MARK	DATE	DESCRIPTIONS	BY	CH'D	CCO#
0	03/08/10	MEP INTEGRATION	JE	FW	110

CONTRACT CHANGE ORDER NO._____
SHEET _____ OF _____

DETAILS
SCADA REMOTE TERMINAL UNIT SYSTEM
RTU #17 ASSEMBLY
NO SCALE

E-952

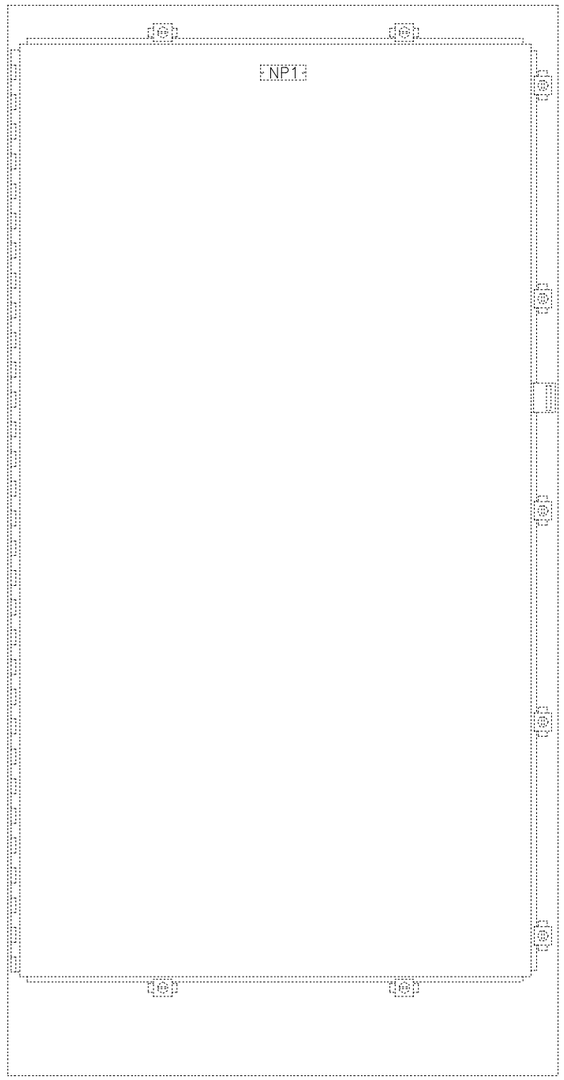
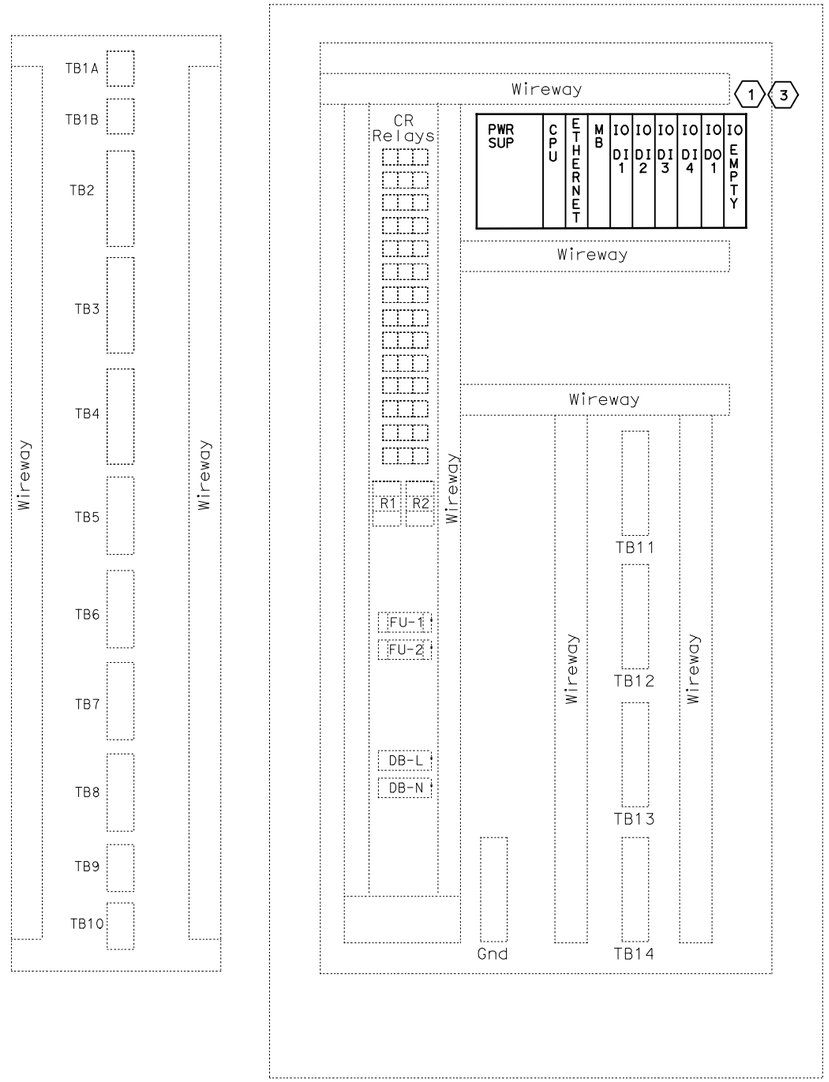
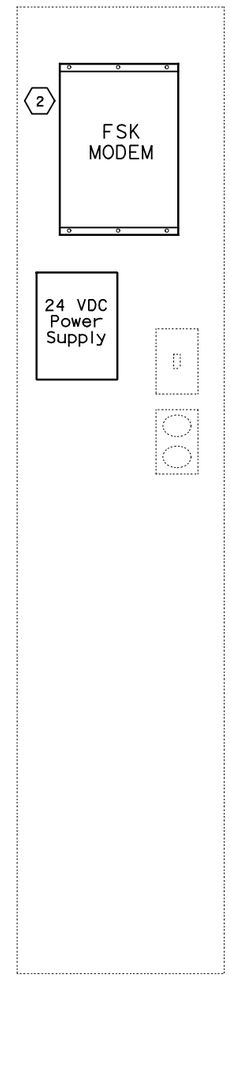
(1) Contractor shall furnish and install a new GE Fanuc PAC Systems RX3i PLC in the existing RTU.

(2) Contractor shall provide and install a new Frequency Shift Key (FSK) modem and 120v (AC) to 21v-28v (DC) power supply in the existing RTU.

(3) Contractor shall install the input and output cards.
